UNIVERSITY OF FLORIDA  
TRAINING REACTOR  
LICENSE NO. R-56  
DOCKET NO. 50-83

APPLICATION FOR CONVERSION FROM  
HIGH-ENRICHED TO LOW-ENRICHED  
URANIUM FUEL

Amendment 25  
UFTR Technical Specifications

UNIVERSITY OF FLORIDA TRAINING REACTOR  
FACILITY LICENSE: R-56, DOCKET NO. 50-83  
REQUEST FOR CHANGE IN TECHNICAL SPECIFICATIONS  
APPROVING HEU TO LEU CONVERSION

Figure 4-3 HEU Fuel Bundle XY Cut

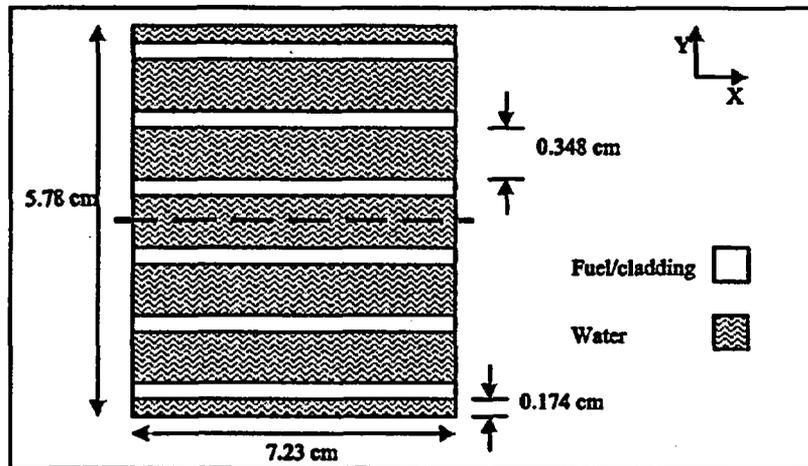
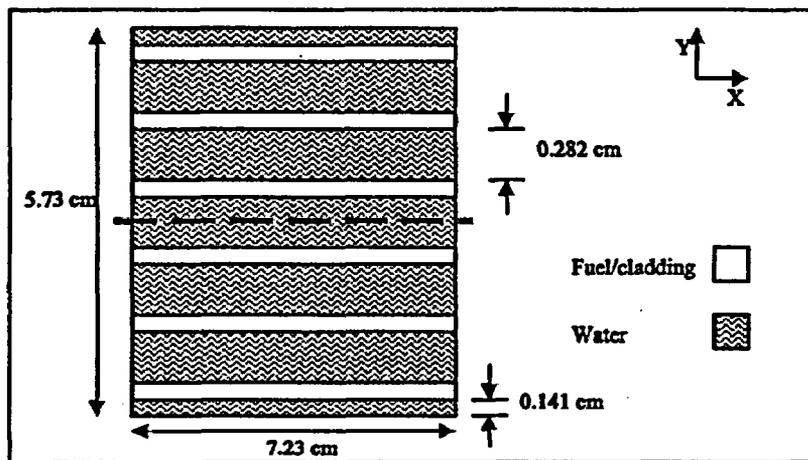
Each HEU fuel bundle is composed of 11 fuel plates. A water gap of 0.348 cm is provided between the fuel plates for coolant flow as illustrated in Figure 4-3.

The LEU fuel bundles are composed of 14 fuel plates with a water gap of 0.282 cm. Figure 4-4 depicts the layout of the fuel plates and water gaps in a LEU fuel bundle.
